IN THE DRAWINGS:

REMARKS

FIG. 1

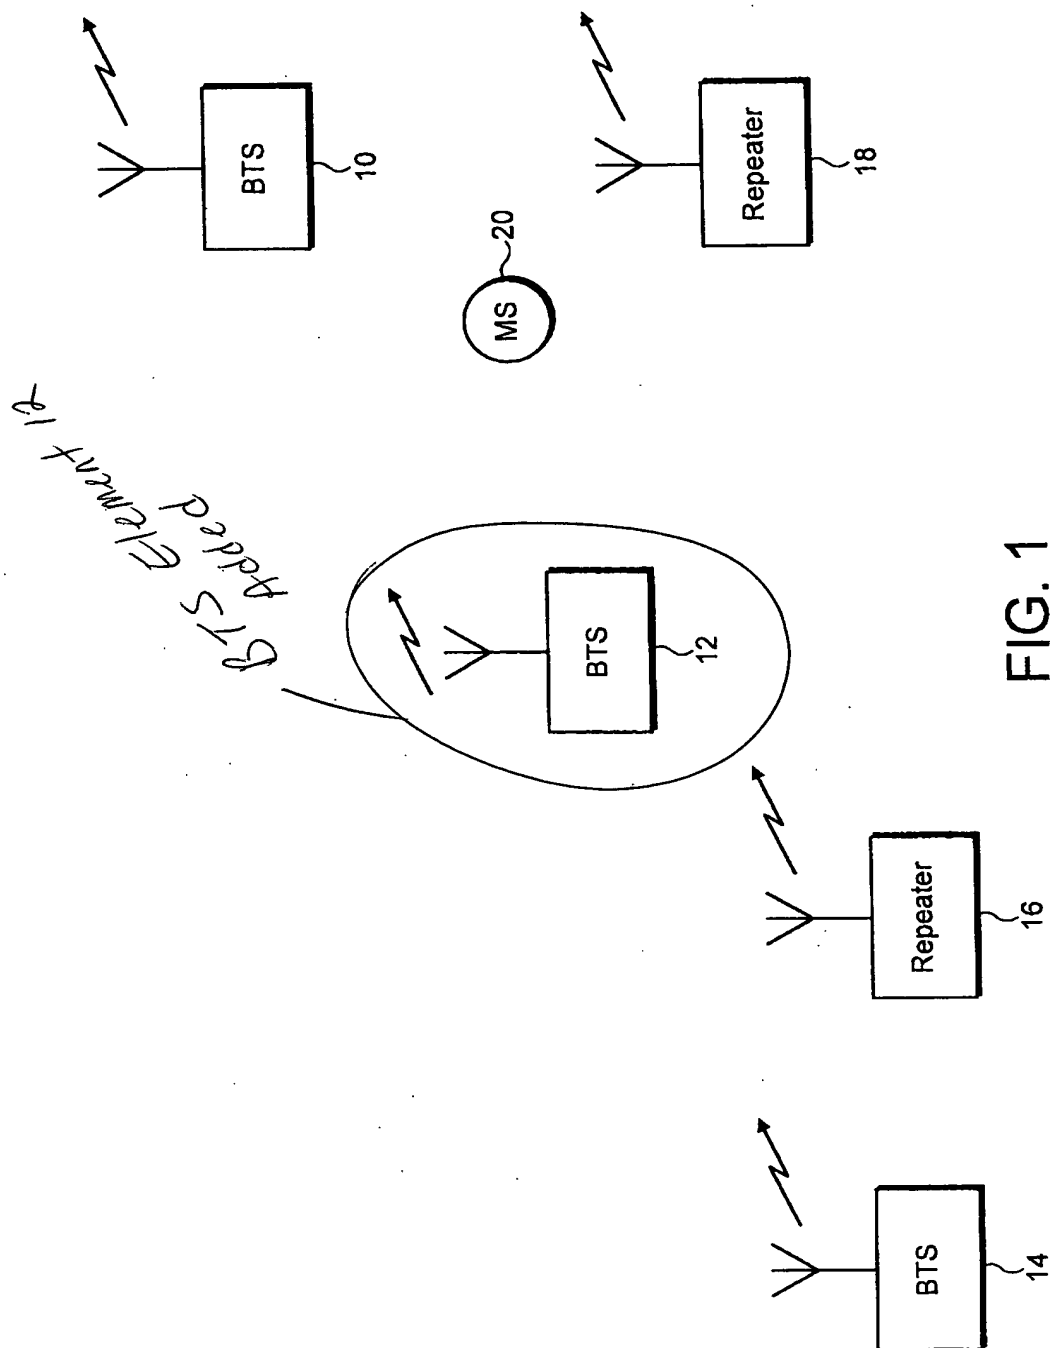
The attached sheet of drawings includes changes to Figure 1. This sheet, showing Fig. 1, replaces the original sheet of Fig. 1, which did not include an illustration of base transceiver station (BTS) 12, which has been added.

In amended Figure 1, the previously omitted base transceiver station (BTS) 12 has been added. The Examiner's approval of the drawing corrections shown in red ink on the attached sheet is respectfully requested.

A Replacement Sheet has been submitted for Figure 1. The original Figure 1 did not include an illustration of BTS 12, which is added in this new figure. However, no new matter has been added. BTS 12 is discussed in detail in the specification, including page 8, lines 27-30, page 9, lines 6-26, and elsewhere in the specification. It is therefore respectfully requested that this Replacement Sheet be accepted, and that claims 35-68 be examined in due course. A Replacement Sheet and an Annotated Sheet is attached, in compliance with 37 C.F.R. 1.121.
